SIB 61 06 21 WIRING HARNESS CHAFING AGAINST ENGINE

2021-04-15

E-Series	Model Description
K63	S 1000 R
K67	S 1000 RR
K69	S 1000 XR

Service Information Bulletin

Figure 1: DETECTION OF A CHAFING MARK VIA THE LEFT SIDE

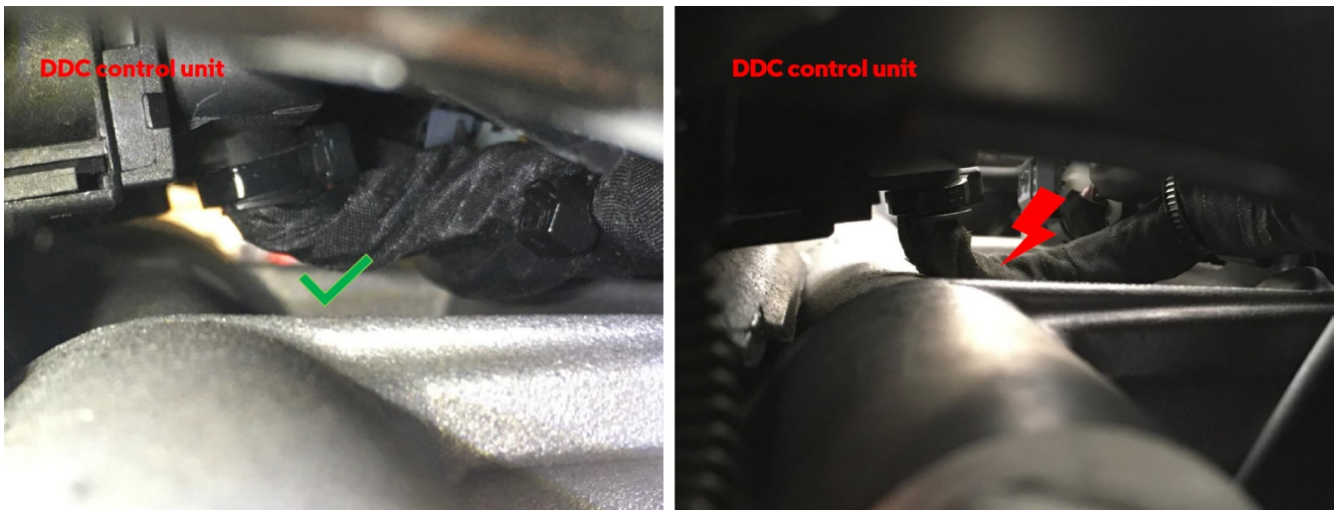
Warning light in the instrument cluster for DCC failure in motorcycles equipped with DCC. This issue may be caused by chafing of the wiring harness.

Determine if chafing is present, using Figures 1 and 2. Continue with repair, following Figures 3-8.

Figure 1: DETECTION OF A CHAFING MARK VIA THE LEFT SIDE

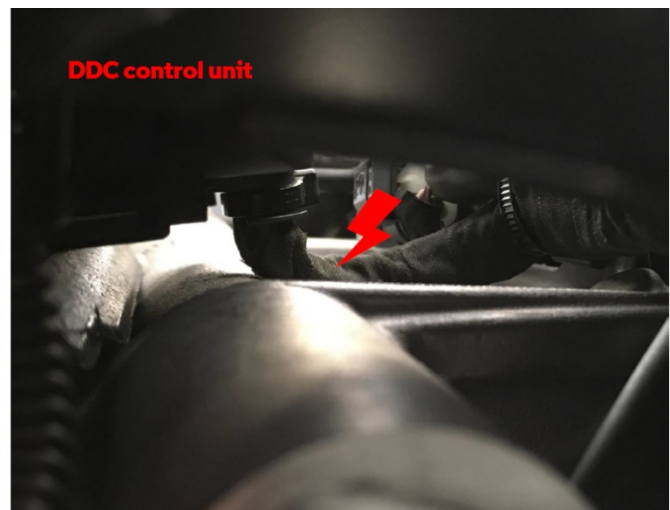
Warning light in the instrument cluster for DCC failure in motorcycles equipped with DCC. This issue may be caused by chafing of the wiring harness.

Determine if chafing is present, using Figures 1 and 2. Continue with repair, following Figures 3-8.

COMPLAINT: DDC FAILURE DETECTION OF A CHAFING MARK VIA THE LEFT SIDE

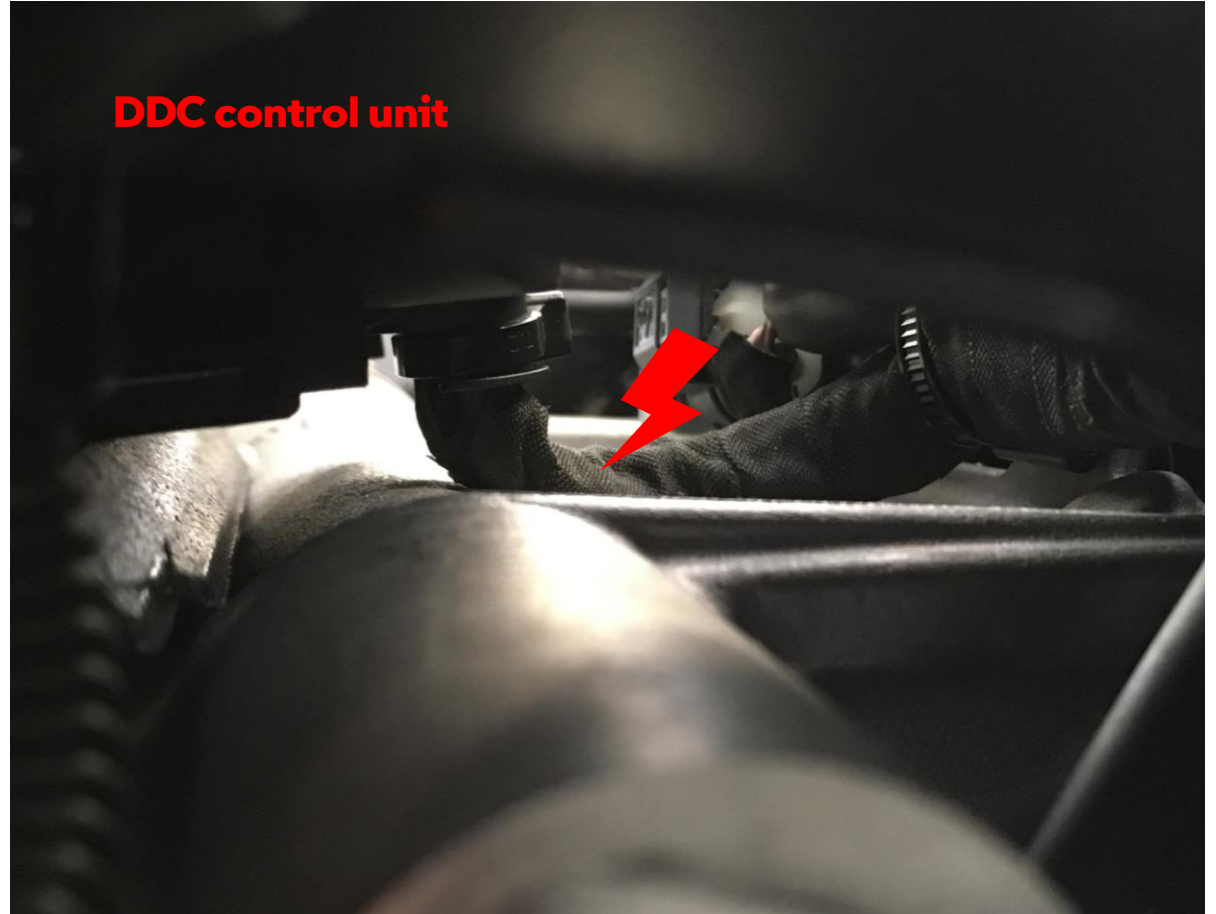
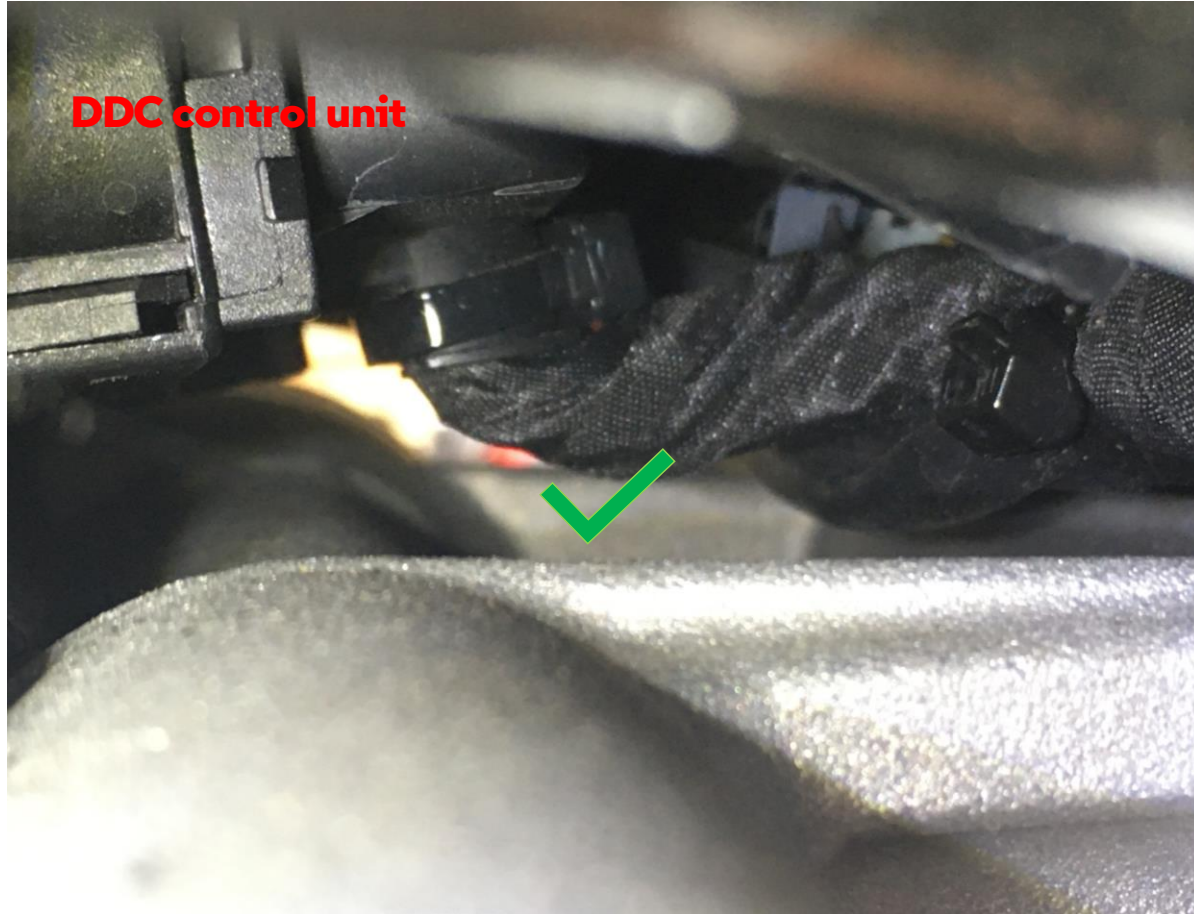
CHAFING MARK ON THE WIRING HARNESS TO THE CRANKCASE
